Office State of New Mexico	Form C-103 May 27, 2004
Submit 3 Copies To Appropriate District Office <u>Cist Act 1</u> 1625 N. French Dr., Hobbs, NM 88240 <u>District II</u> 1301 W. Grand Ave., Artesia, NA 62210 <u>District III</u> 1000 Rio Brazos Rd., Aztec, NM 87410 State of New Mexico History, Minerals and Natural Resources CONSERVATION DIVISION 1220 South St. Francis Dr.	WELL API NO.
District II	30-015-38519
1301 W. Grand Ave., Artesia, National Conservation District III	5. Indicate Type of Lease
1000 Rio Brazos Rd., Aztec, NM 87410\\\	STATE ☐ FEE ☒
District II 1000 Rio Brazos Rd., Aztec, NM 87410 District IV 1220 S. St. Francis Dr., Santa Fe, NM 87505 Proof gy, Minerals and Natural Restances	6. State Oil & Gas Lease No.
SUNDRY NOTICES AND REPORTS ON WELLS	7. Lease Name or Unit Agreement Name
(DO NOT USE THIS FORM FOR PROPOSALS TO DRILL OR TO DEEPEN OR PLUG BACK TO A	Long Branch
DIFFERENT RESERVOIR. USE "APPLICATION FOR PERMIT" (FORM C-101) FOR SUCH PROPOSALS.)	8. Well Number

1. Type of Well: Oil Well Gas Well Other	2
2. Name of Operator	9. OGRID Number
Marathon Permian, LLC	372098
3. Address of Operator	10. Pool name or Wildcat
5555 San Felipe Houston, TX 77056	Glorieta Yes

Wel

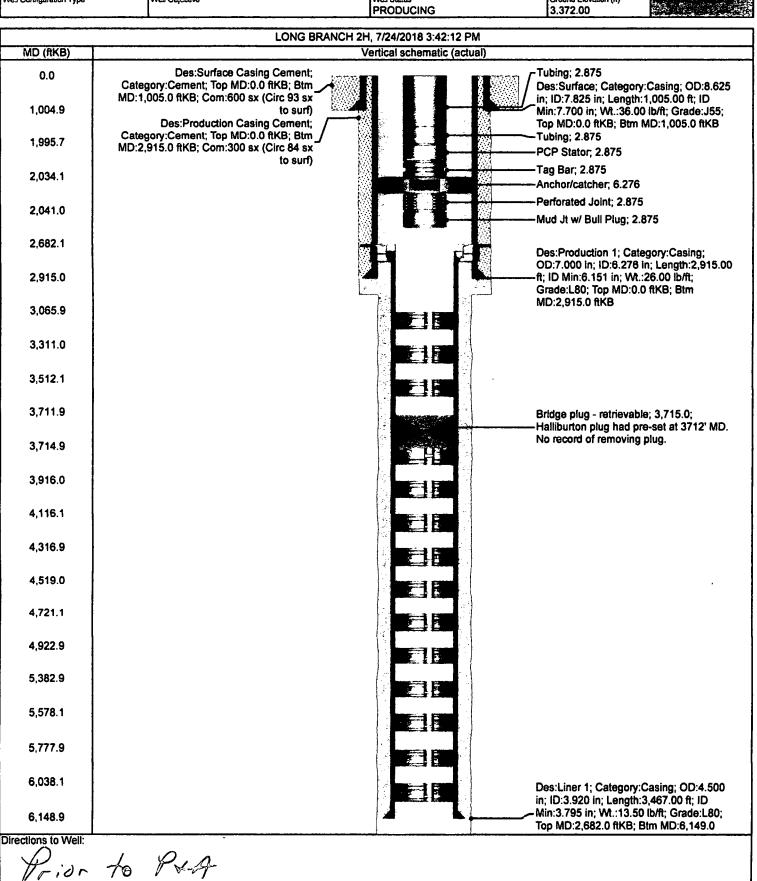
13. Describe proposed or completed operations. (Clearly state all pertinent details, and of starting any proposed work). SEE RULE 1103. For Multiple Completions: Att or recompletion. CIBP @ 27 72 1. 25 sx at 2,742' - 2,642' tag (across liner top) 2. 25 sx at 1,055' - 955' tag 3. Perf at 100'. Cement to surface with 30 sx. Verify Install D.H.M. P&A mud between plugs, closed loop all fluids to licensed facility. Musical March 1997. August 19	RECEIVED JUL 26 2018 DISTRICT II-ARTESIA O.C.D. H Se Plassed by 8-2-19 and belief. I further certify that any pit or below-

AFTER P+A
